**WHITE LAKE TOWNSHIP
INTER-OFFICE MEMORANDUM
COMMUNITY DEVELOPMENT DEPARTMENT**

SUBJECT: **Edendale Crossing**
Preliminary site plan approval
Rezoning request approval
Property described as parcel numbers 12-29-476-016 through 12-29-476-024, located northwest corner of Bogie Lake Road and Cedar Island Road, consisting of approximately 45.47 acres.

RE: Edendale Crossing- Preliminary Site Plan Review – 4th Review

**Preliminary Site Plan / Site Condominium / Planned Development Review
for
White Lake Charter Township, Michigan**

Drawn by:
LZ
Checked by:
JTE
Date:
December 18, 2025
Scale:
As Noted
Not for Construction
Sheet
L-3

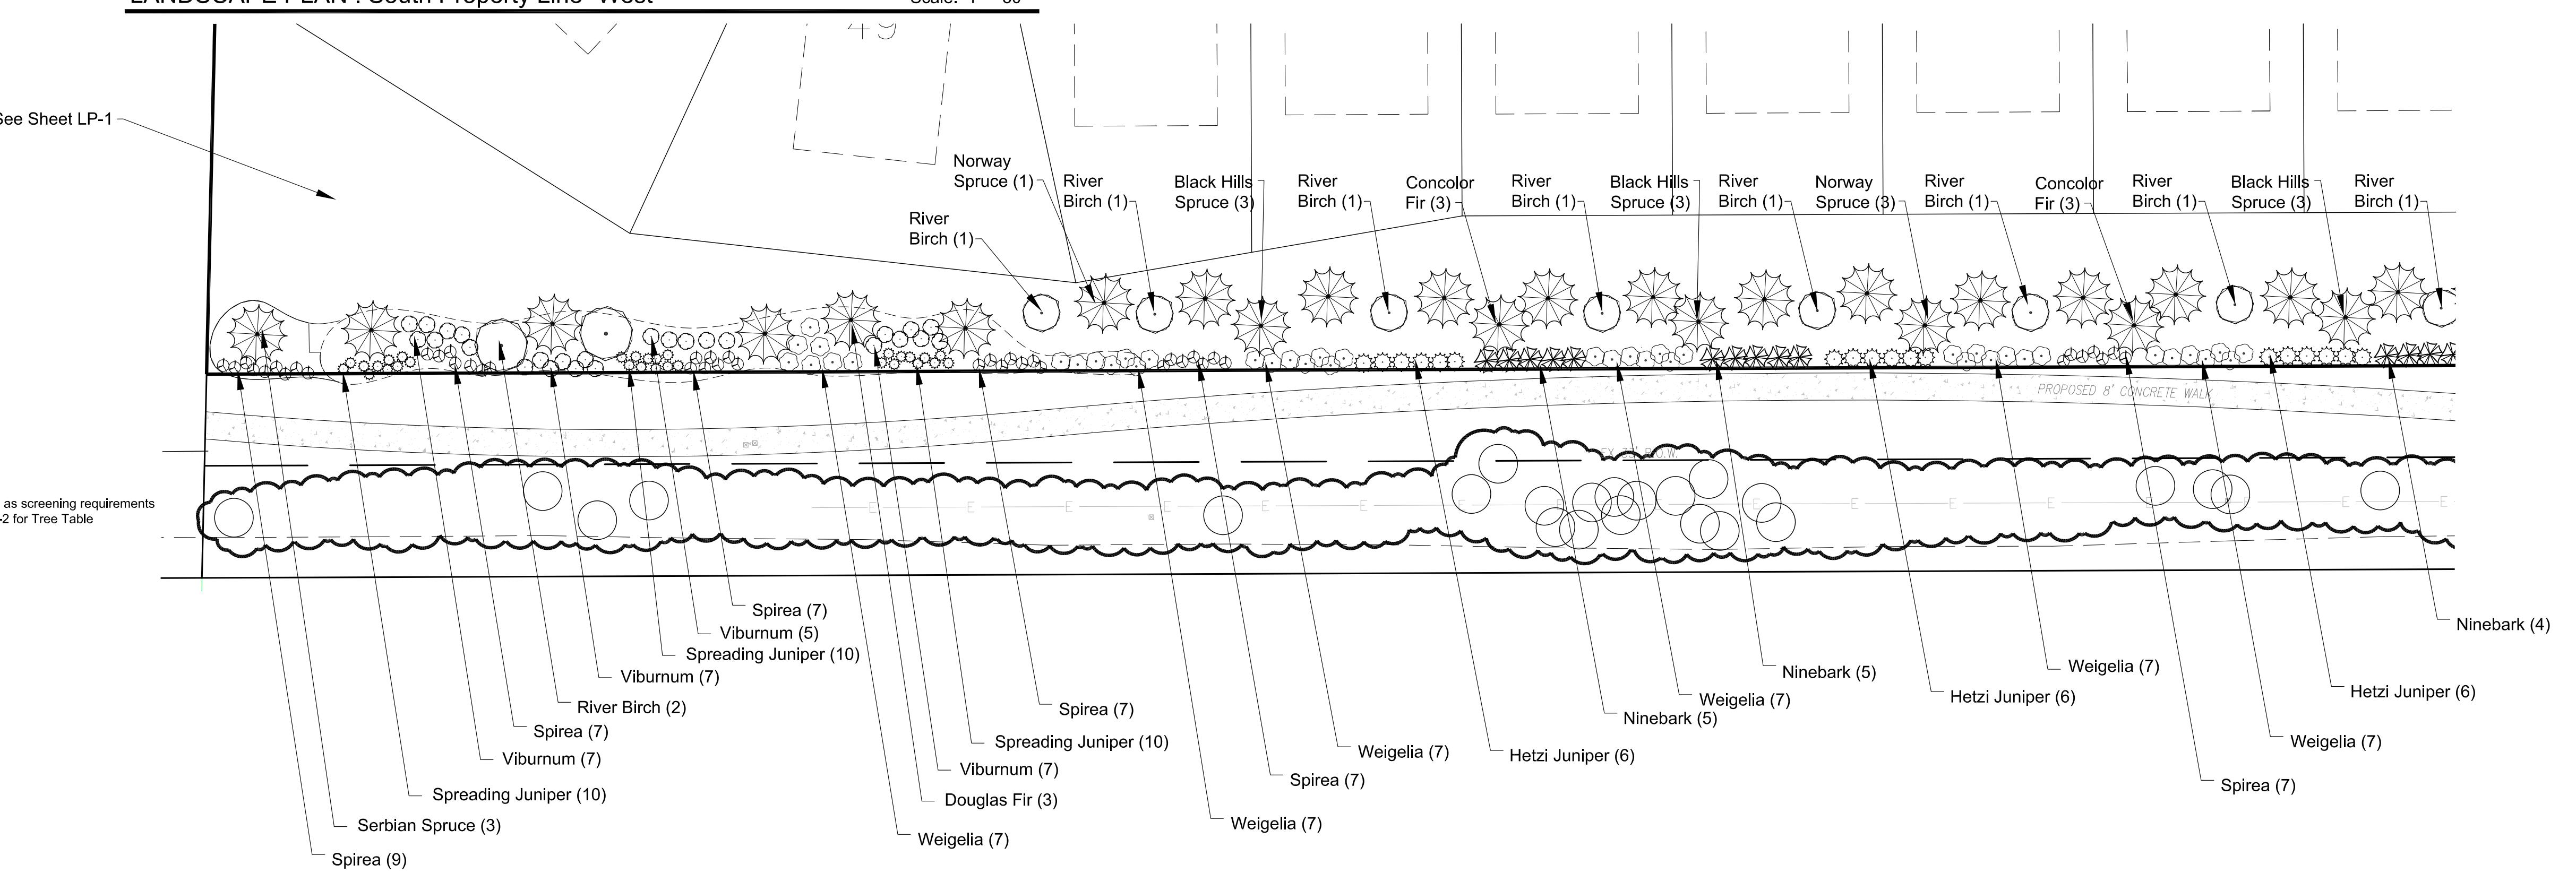
The applicant has provided a landscape plan on Sheets L-1, L-2, and L-3. Landscaping plans are required at final site plan review.
